Model: PRIPORT PINKGOLD		Date: 20-May-02	No: M-C238-001
Modified Article: Thin pads		Prepared by: H. Onodera	
From: Priport Service Planning Section			
Classification: ☐ Parts catalog correction ☐ Vendor change ☐ To meet standards ☐ To facilitate assembly ☒ To improve reliability () ☐ Part standardization ☐ Other ()			
Model Name: Ricoh JP3000/JP3800, Gestetner 5430/5428C, RexRotary 1330, nashuatec CP430, Savin 3260DNP, Standard SD370

Model: PRIPORT PINKGOLD		Date: 30-Oct-02	No: M-C238-002
Modified Article: New model PG B4 information (China only)		Prepared by:	
From: Priport Service Planning Section		H. Onodera	
Classification:	☐ Parts catalog correction ☐ Vendor change ☐ To meet standards ☐ To facilitate assembly ☐ To improve reliability () ☐ Part standardization ☒ Other (New machine information)		
Model Name: PINKGOLD: Ricoh JP3000/JP3800, Gestetner 5430/5428C, RexRotary 1330, nashuatec CP430, Savin 3260DNP, Standard SD370, Lanier LDD030 PG B4 (China only): Ricoh JP2800, Gestetner 5425C

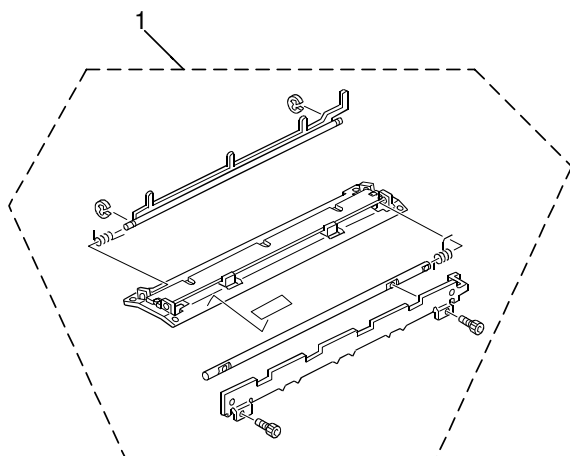
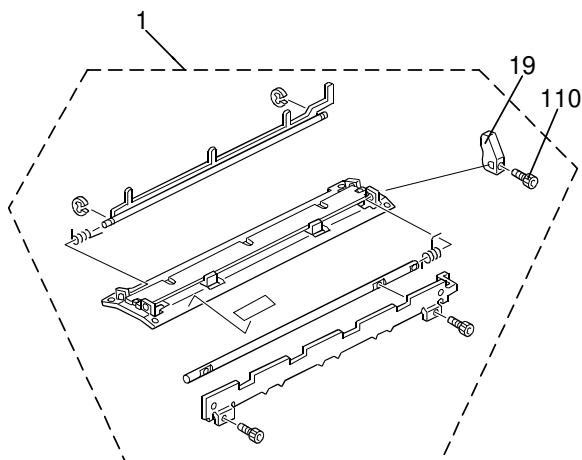
The clamper assembly has been changed to include the Clamper Cam (#19 below) and Hexagonal Set Screw (#110 below) to further facilitate servicing in the field.

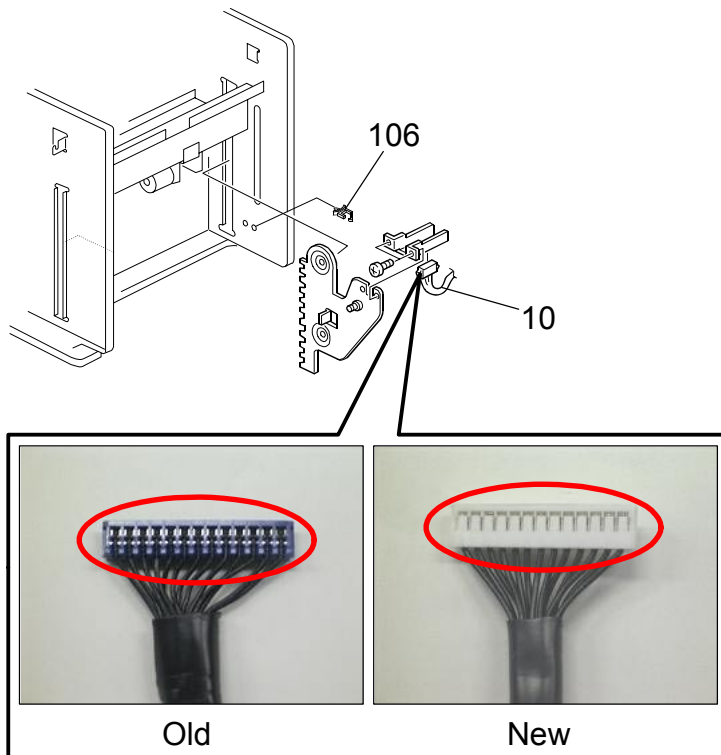
Change: The shape of paper tray harness was changed.

- When you install the new C2475237 Paper Tray Harness on machines before the cut-in S/N, install it **together as a set** with the new 11050516 Clamp.
- P/N 11050511 was missing from the PINKGOLD Parts Catalog.
- P/N 11050516 was also added for parts standardization with the HP4.
- See RTB #RC238018 for more details.

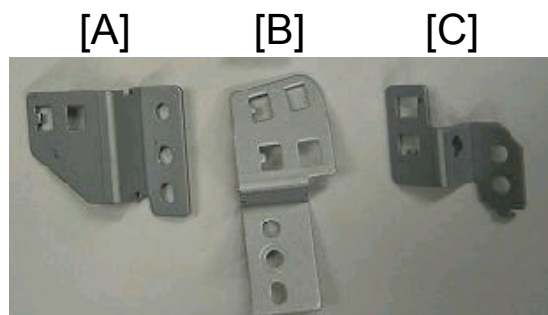
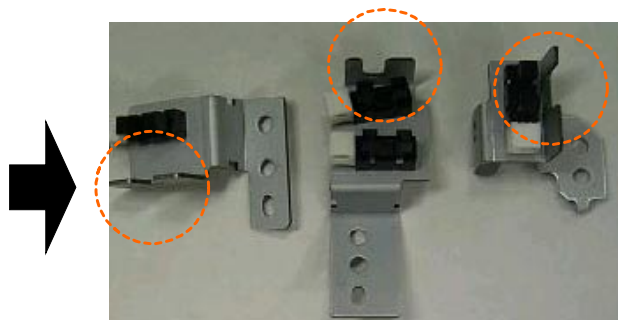
Change: Shape change.

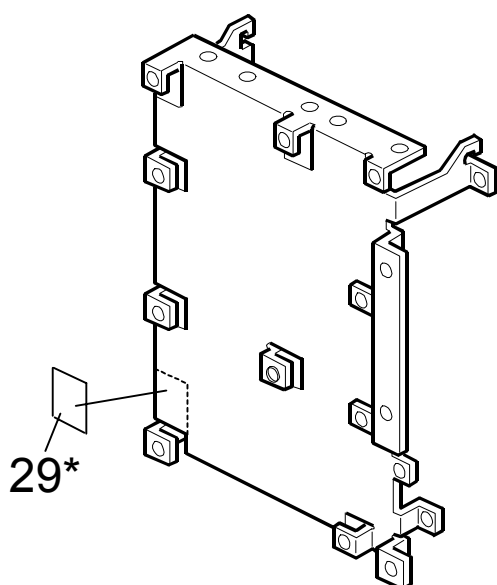
Change: The part shown below was added to the MPU bracket (P/N C2385601).

Reason: To ensure that the paper tray harness (P/N C2475237) stays in the correct position.

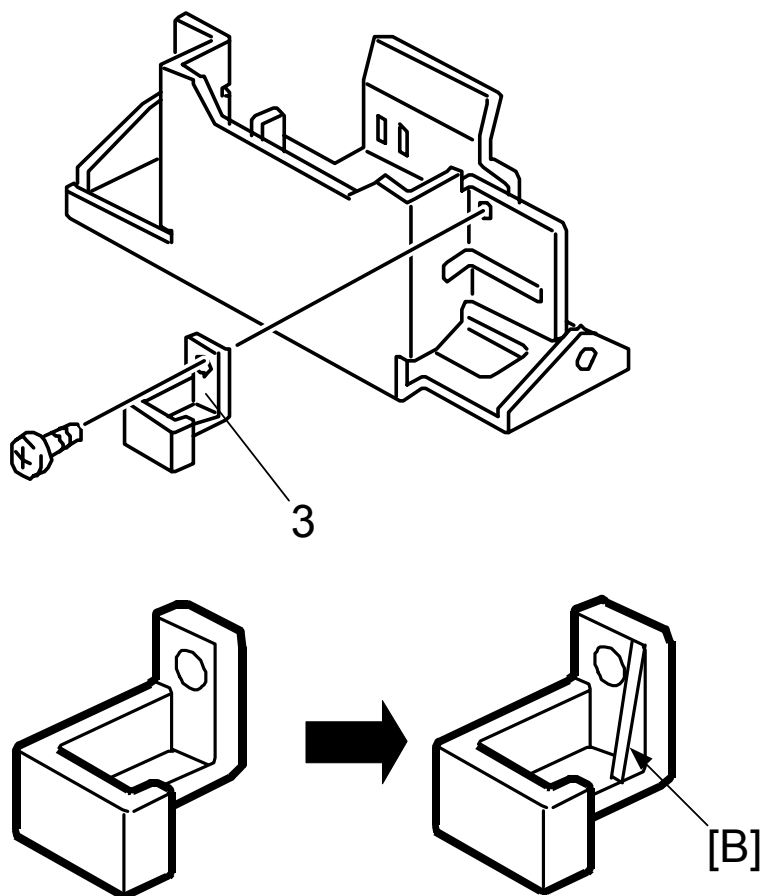
Change: A rib [B] was added to the “GRIP INK ASS'Y”.

13. Drum Unit 2 (pg. 30)

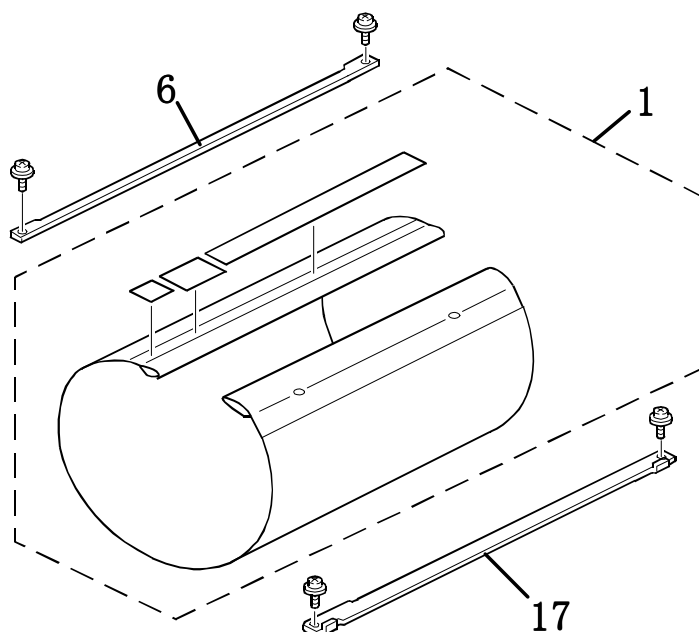
Change/Reason: The illustration below was corrected.

Correct: The part marked as index “1” does not include the parts marked as index “6” and index “17”.

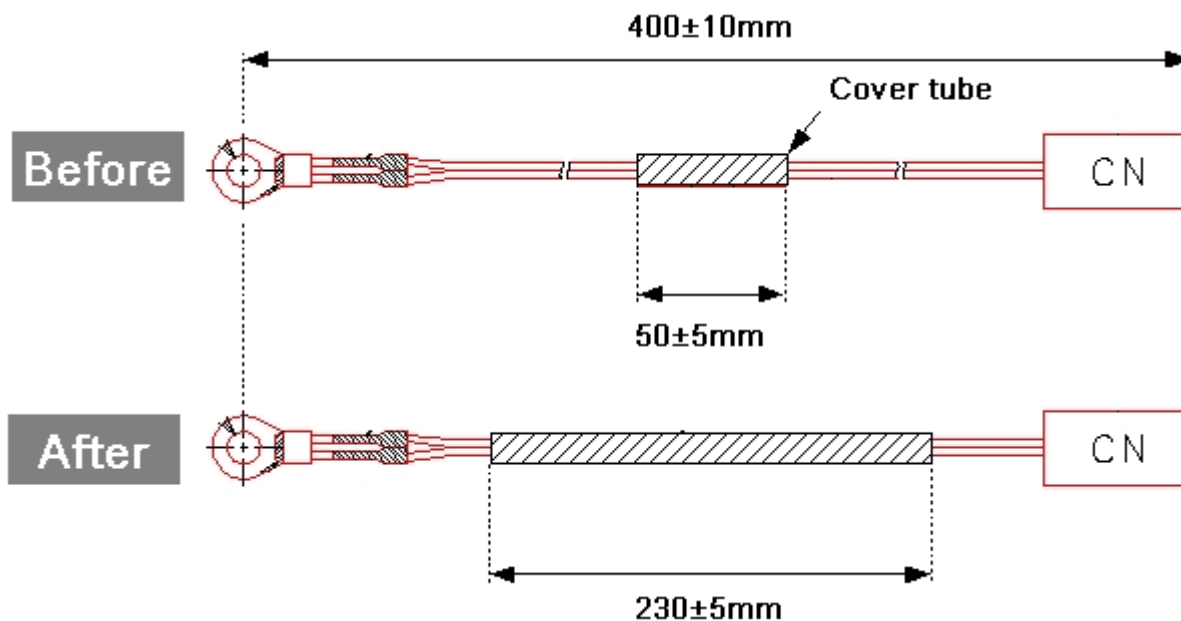
Change: The length of the cover tube for the thermistor was increased from 50 mm to 230 mm.

Reason: Parts standardization with the EMERALD/TOPAZ (C262/C265). Also, the new part protects the thermistor better.

8.Paper Registration (C264)

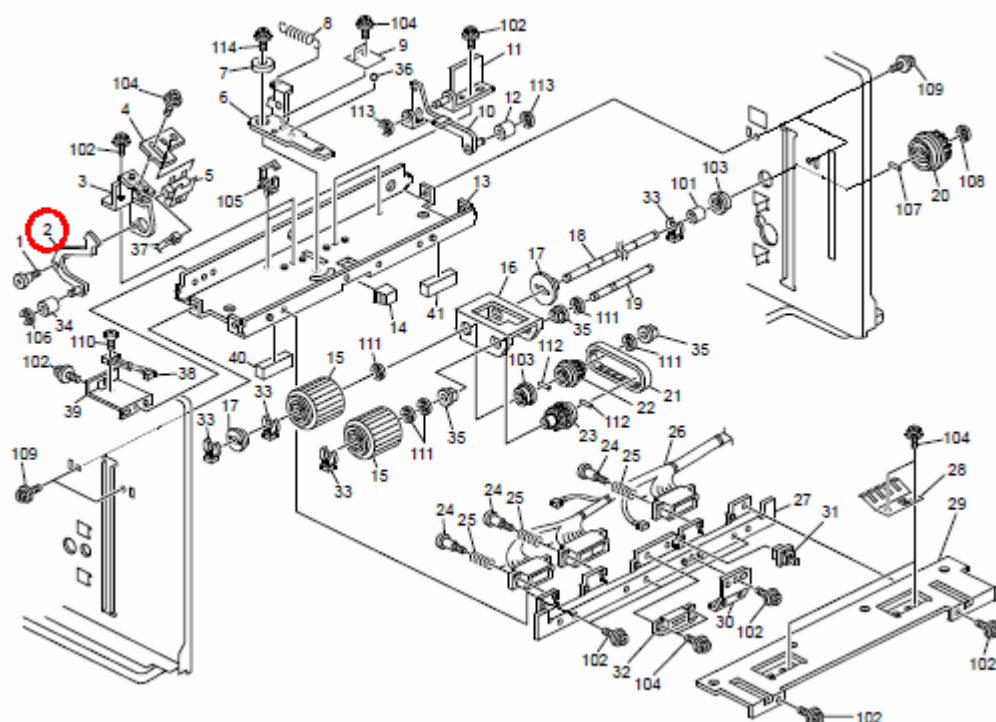
Change: The shape of the paper actuator was changed.

Reason: To ensure that the paper actuator does not touch the pick-up roller during paper feed (which can cause E-02, paper table drive error).
